## WINSTAR Display Co.,Ltd.

Subject: Comparing Winstar HDMI board to supporting different Raspberry PI version. The outline appearance and construction are all keep the same, the only difference is in the CON4 and CON5.

Comparing the end of the parts number in "X#" and "V#"

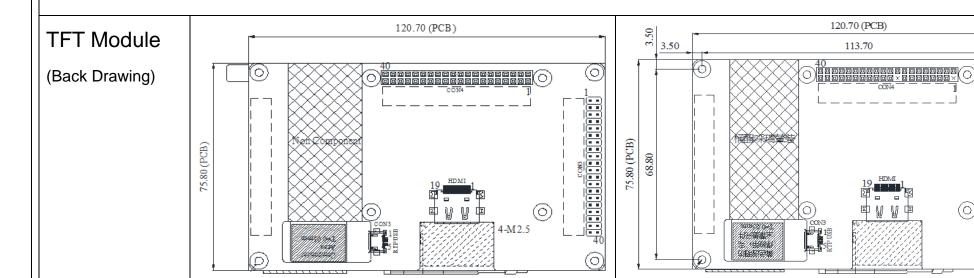
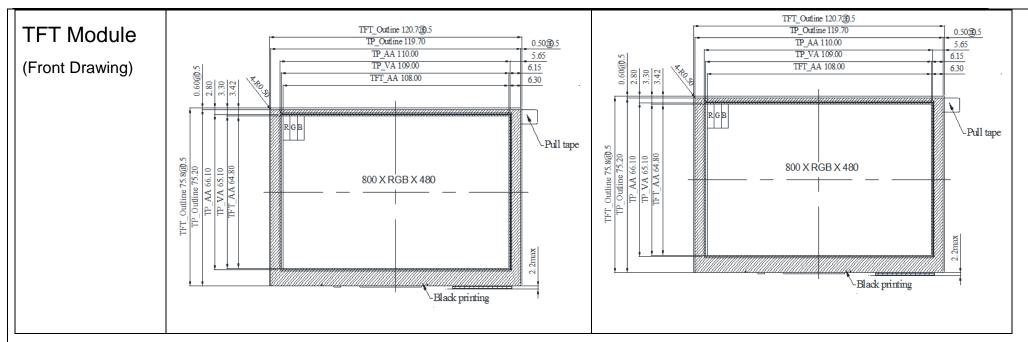
For example parts number	WF50BTIFGDHGX# Supporting Raspberry Pi1 ~ Pi3/Pi3B Only					WF50BTIFGDHGV#  Supporting Raspberry Pi Pi1 ~ Pi3/Pi3B and Pi3B+					
Scope of use											
CON4/CON5 (PIN Define)	. LCM PIN Definition(CON4/CON5)					LCM PIN Definition(CON4)					
	Pin∉	1 ******	Function	Remark₽		Pin∉		Function <sub>e</sub>	Remark∂		
(1 114 2011110)	l <del> </del>	<u> </u>				1 <i>₽</i>	NC∉ NC∉	No connection ∂  No connection ∂	<i>₽</i>		
	1₽	3.3V₽	1 2				LCM PIN Definition(CON5)		+		
	17₽	3.3V₽	Raspberry Pi:3.3V	₽		Pin₽		Function₽	Remark∂		
		•	•	'		1∉	3.3V₽	TFT Module Power limit can only output 3.3V,100mA	NOTE1₽		
						17₽	3.3V₽	TFT Module Power limit can only output 3.3V,100mA <sub>€</sub>	NOTE1₽		
						Note1: The 3.3V supply current is limited in 100mA; please note.					
CON4 different (CON4 Drawing)		40						40 00000000000000000000000000000000000

If we keep input 3.3V from CON4 for Raspberry Pi 3B+, the display is error. After changing 3.3V to NC, the display is working correct. In order to support the new version of Raspberry [Pi3B+], we develop the new version in V#.

For the new project, please promote in V# for further.
